Amendments to R78

Documents: ECE/TRANS/WP.29/2008/64 and GRRF-64-15

Annex 1: NHTSA test results

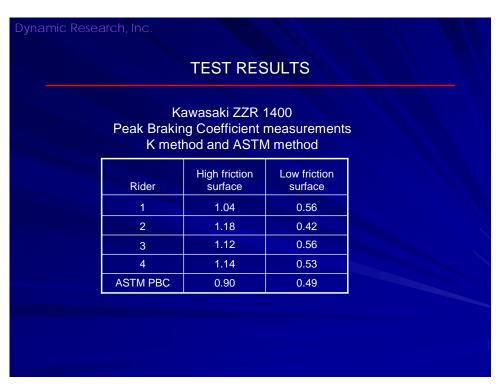
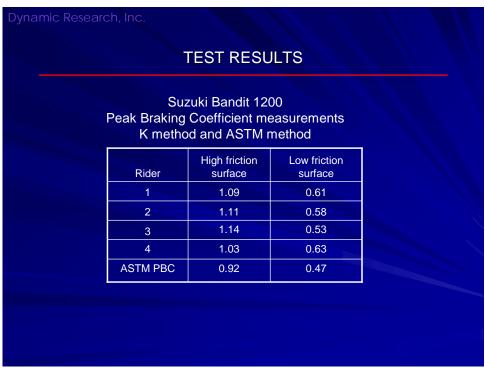
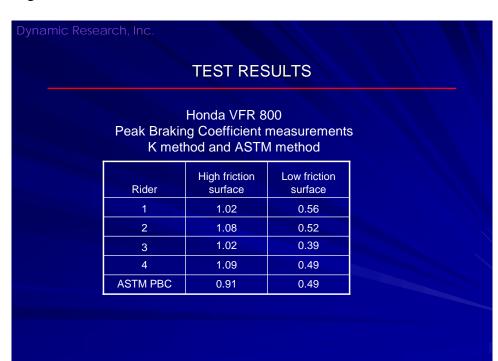
- The NHTSA tests had surfaces of more than 0.9 (*Annex 1*) and 0.9 is considered normal in the industry
- The text would allow testing on any surface, so the surface would not be harmonised.
- R78 would no longer be harmonised with the GTR.
- Allowing a lower PBC surface would require a discussion of the performance requirements, as these are linked to the surface value. For example, the requirement is, "MFDD shall be 6.17 m/s2". If the surface PBC is (for example) 0.62, to prevent rear-wheel lift with ABS fully cycling the ABS effectiveness would have to be 100%. If a wider range of PBC surfaces can be used it is necessary to review/change the performance requirements
- It is impractical to repeat tests on a new track if rear-wheel lift occurs.

Annex 2: ABS traces

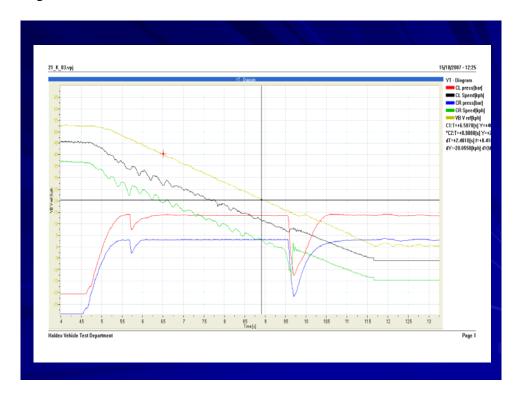
- although this may be true for other vehicles e.g. trucks, it is not true for motorcycles. The ABS system cycles too frequently for this to work (example traces of a truck and a motorcycle are shown in *Annex 2*)
- in the "inoperative ABS" method, the setting value of the limiting valve when carrying out the k measurement is set "slightly above ABS operative pressure". It is therefore likely that the ABS will influence the result if it cycles

The industry considers that this text may lead to confusion and incorrect test results. IMMA therefore requests that this text be returned to the original:

"(b) The anti-lock system shall be disconnected"
